ACME TOWNSHIP ZONING BOARD OF APPEALS
ACME TOWNSHIP HALL
6042 Acme Road, Williamsburg MI 49690
August 30th, 2017 7:00 p.m.

- D. PUBLIC HEARINGS:**
1. ZBA 2017-03: Non-Use Variance Requests, Archangel Gabriel Orthodox Church, 7111 US-31 N
 - a. Request Mark Humitz, President of Cornwell Architects

Planning and Zoning Staff Report

Permit No.: ZBA 2017-03

Exhibit B Landscape Plan

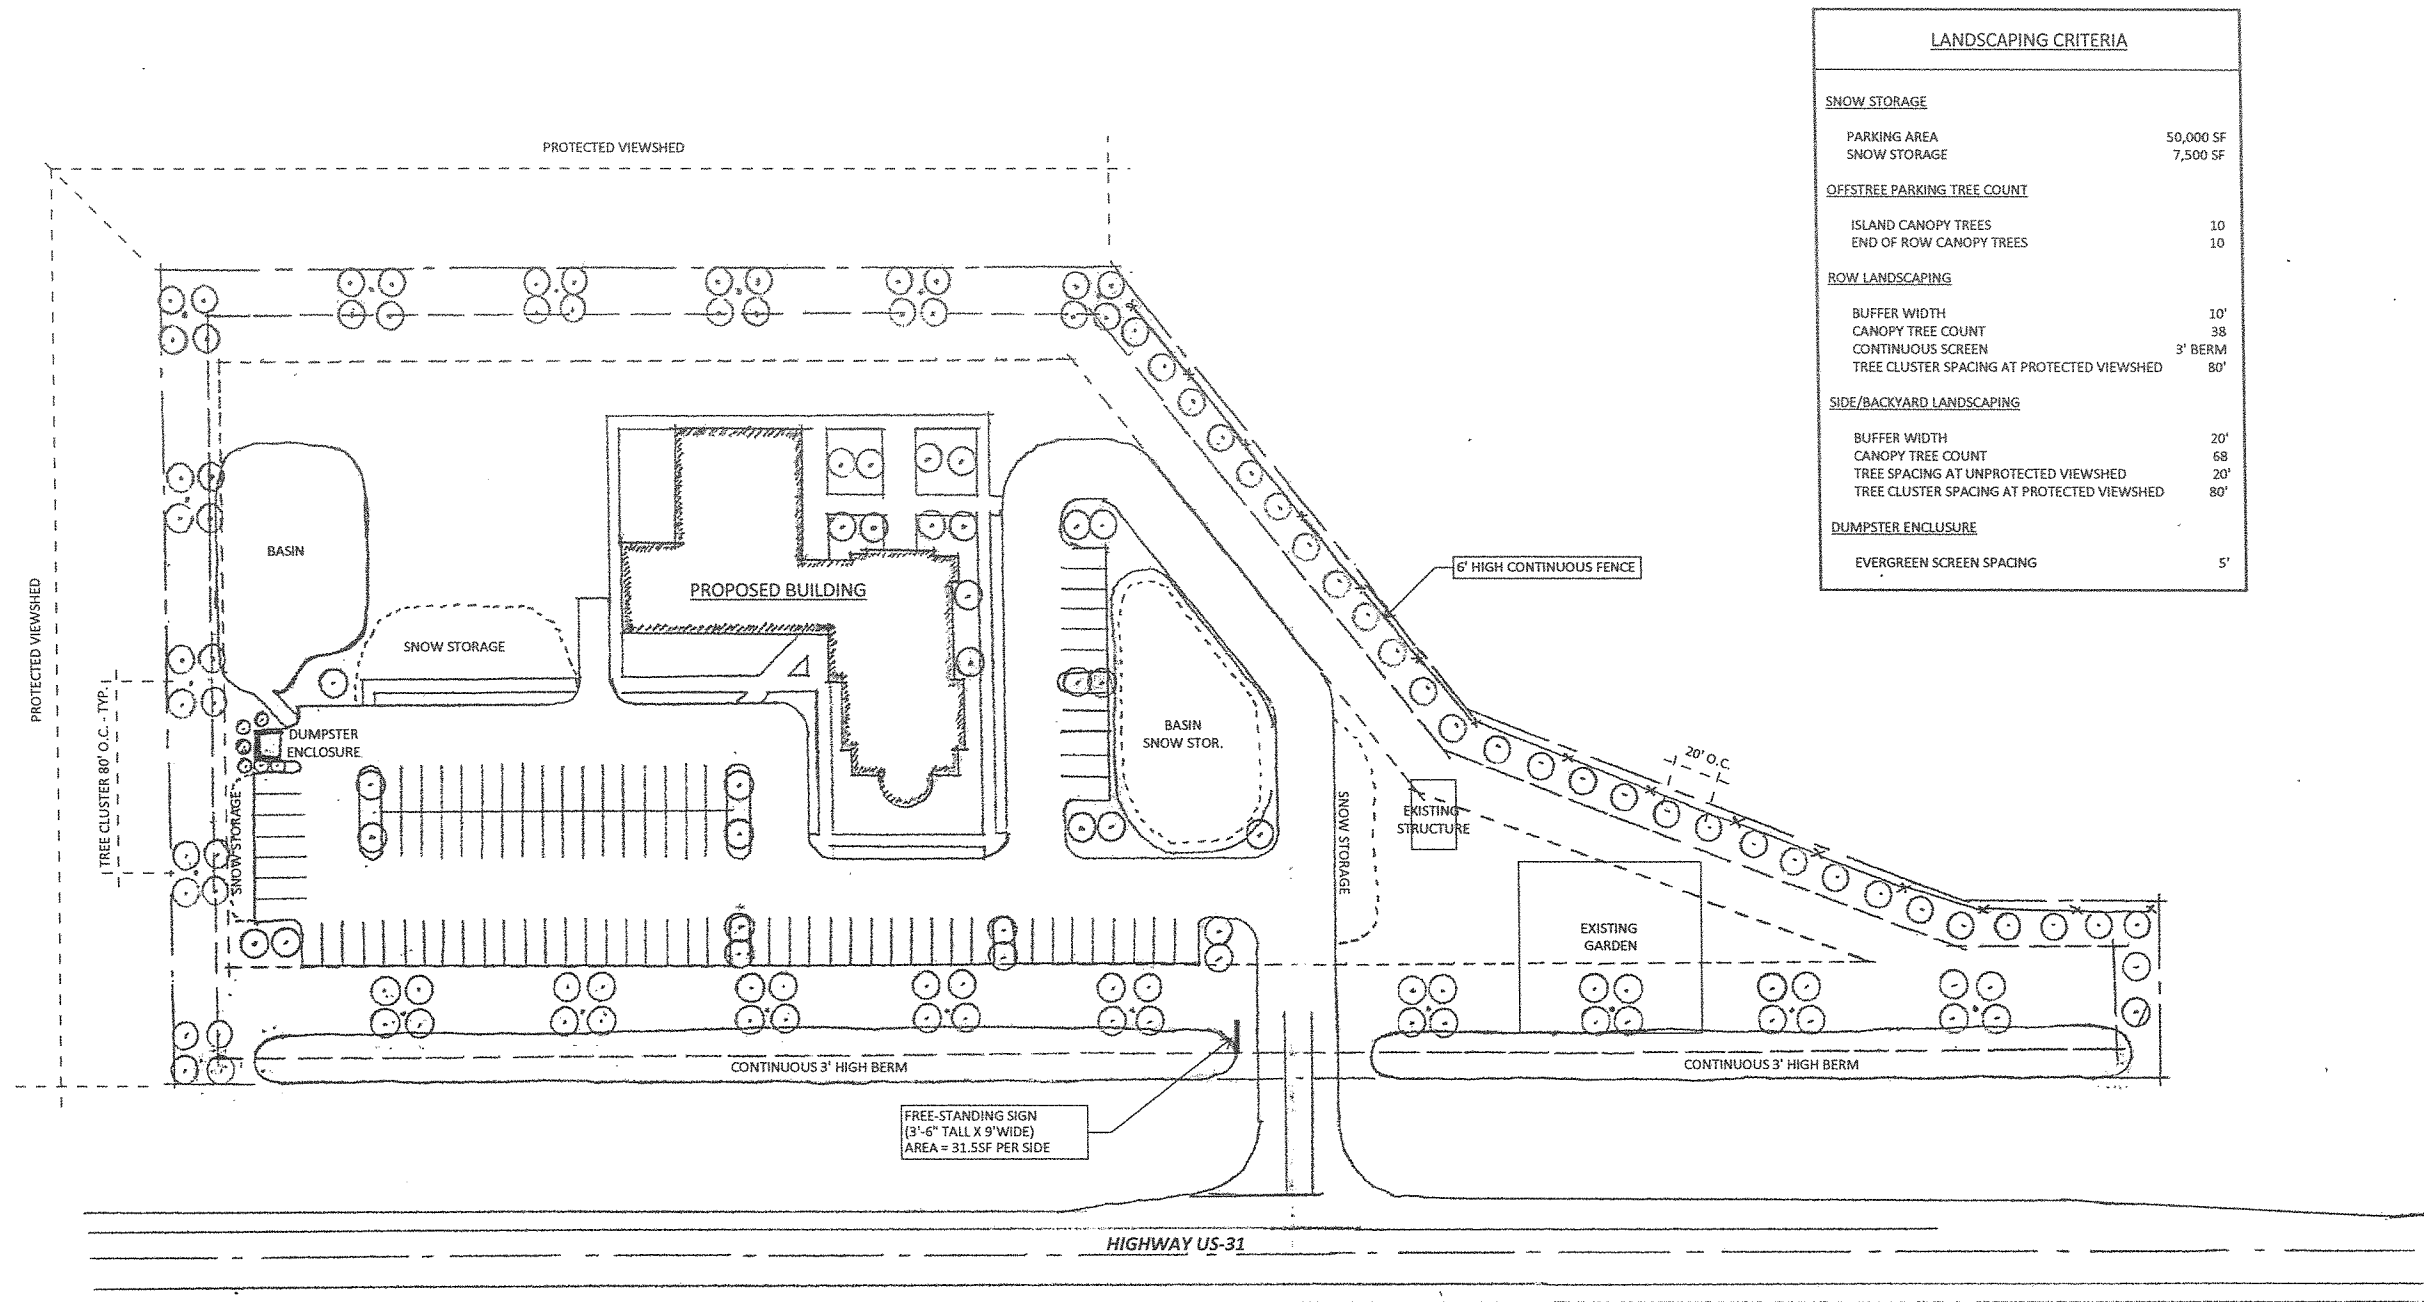
Eighteen (18) canopy/evergreen trees are required along the 420 ft of parking lot on US-31 N. The Applicant is proposing twenty (20) canopy trees clustered in groups of four (4) and is requesting to place the clusters eighty (80) ft apart as opposed to the maximum spacing of thirty-five (35) ft.

The Applicant does propose a thirty-six (36) in. high earthen berm along the parking lot, but is requesting to place it along the property line between the proposed clustering of trees, rather than the required four (4) setback from the property line.

5. One canopy or evergreen tree shall be planted for every 20 feet or fraction thereof within the buffer area.
Based on the 1,413 ft. of rear and side property lines, seventy-one (71) canopy/evergreen trees are required. The Applicant's plan indicates seventy (70) trees. The Planning & Zoning Administrator has indicated a location for an additional tree on Exhibit C in the northeast corner.

The Applicant is requesting to plant canopy trees in clusters of four (4) along the right-of-way spaced approximately eighty (80) ft. between clusters. No shrubs are indicated in the plan, but an earthen berm is indicated pursuant with §7.5.6(f)(3) below.

The landscape plan includes a refuse receptacle in the southwest corner of the parking lot near the storm water basin. The Zoning Ordinance requires refuse receptacles be screened on all sides. The landscape plan indicates three sides surrounded by evergreen trees spaced five (5) feet apart. A non-use variance will need to be granted to allow this method of screening. The Planning & Zoning Administrator has recommended a six (6) foot high opaque gate be included in the front of the refuse receptacle area as noted in Exhibit C. Given the location of the refuse receptacle within the viewshed area, the proposed screening method will provide a more natural element across the landscape compared to an opaque screening structure.

2. The clustering of canopy trees in groups of four (4) to be spaced eighty (80) feet apart along the US-31 N right-of-way, the south property line, and the west property line.
3. The screening of the refuse receptacle with evergreen trees.
4. The earthen berm along the US-31 N right-of-way along the front property line in front of the clustered trees.
5. The space between the clustered trees along the property's boundaries and the earthen berm itself to be planted with grass instead of shrubs.

Exhibit C Planning & Zoning Administrator Recommendations

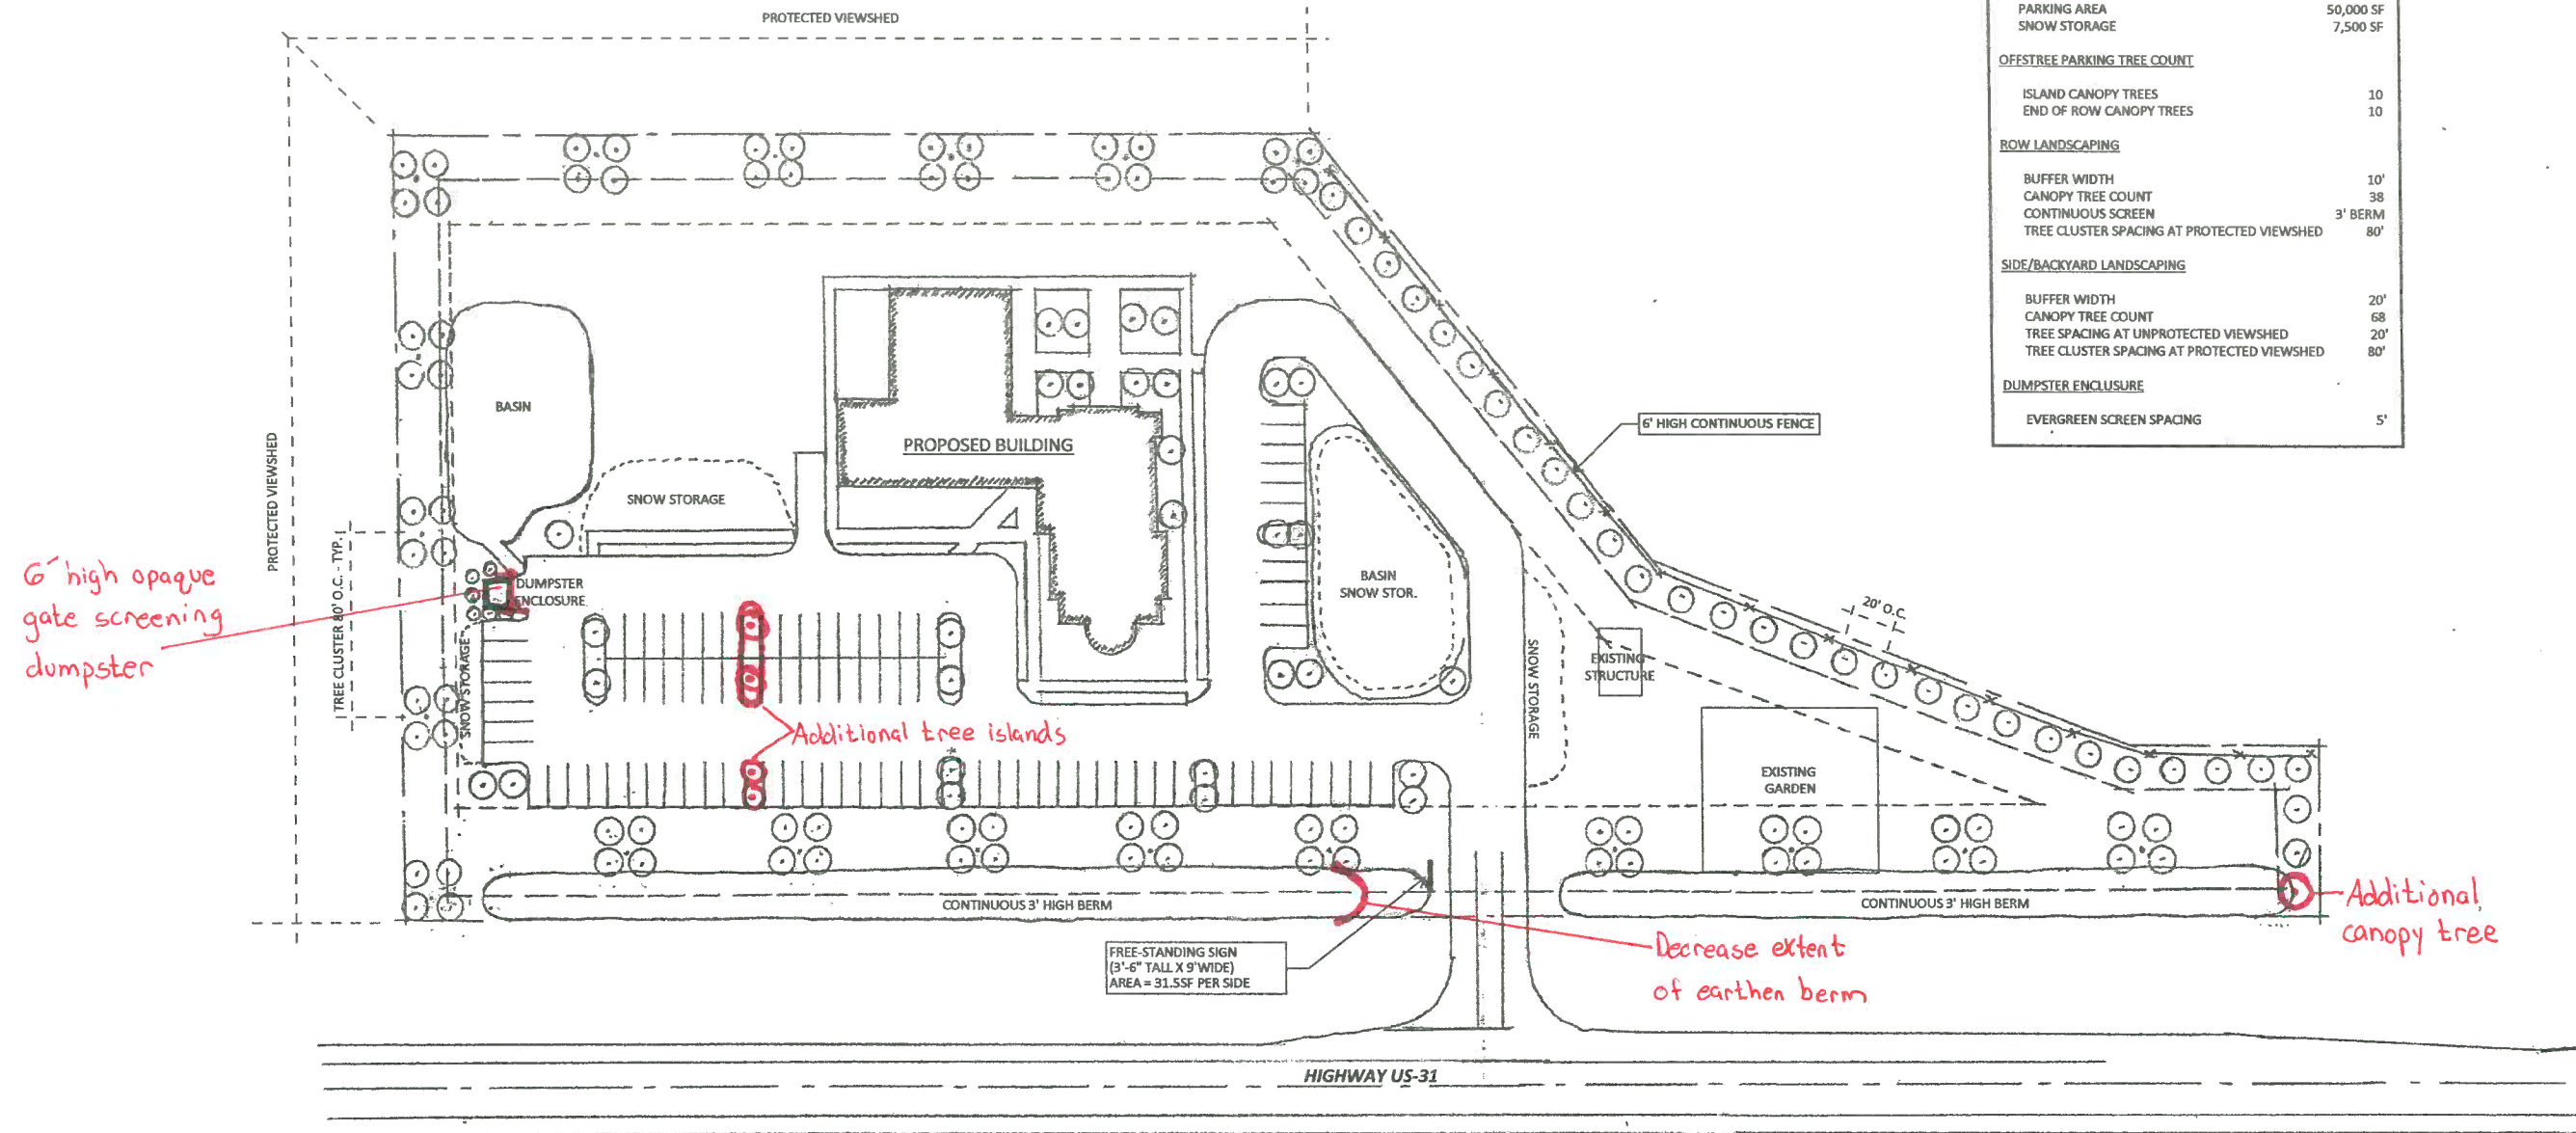
1. The addition of two (2) treed islands to meet the requirements of the Ordinance.
2. A six (6) foot high opaque gate in the front of the refuse receptacle.
3. An additional canopy tree located at the northeast corner to satisfy the number of required trees (71).
4. Reduce the northern extent of the earthen berm on the south side of the driveway as to not obstruct the view of the sign from those traveling north along US-31.

- Eliminate trees along the south and west property lines indicated on the plan as “Protected Viewshed”
- Delay the installation of the 6’ high opaque fence along the northwest property line until requested by a resolution of the LochenHeath HOA

- Berm height along the ROW of 3 feet above highest parking lot grade south of the driveway, truncated on the north end to accommodate the sign as indicated in Exhibit C

- Use of shrubs to create a hedge row 3’ high along the northwest property adjacent to the LochenHeath residential lots.

Motion by LaSusa to accept the findings of fact by the Zoning Administrator and grant the non-use variance request to allow the following as submitted by the Applicant and indicated on the landscape plan identified as Exhibit C with the following changes:

1. The parking shall be located in the front of the yard.
2. Eliminate the required trees along the south and west in the “Protected Viewshed” and the northwest property line adjacent to the LochenHeath lots
3. Substitute the trees adjacent to the LochenHeath lots with low shrubbery
4. Allow the screening of the refuse receptacle with evergreen trees
5. The reduction of the berm’s northern extent south of the driveway as indicated in Exhibit C.
6. Eliminate the required berm north of the driveway
7. Install additional the treed islands as indicated in Exhibit C
8. A 6’ high opaque gate to be placed in front of the refuse receptacle
9. Delay the installation of the opaque fence along the residential lots until initiated by resolution of the LochenHeath HOA
10. Eliminate the required trees along the US-31 ROW
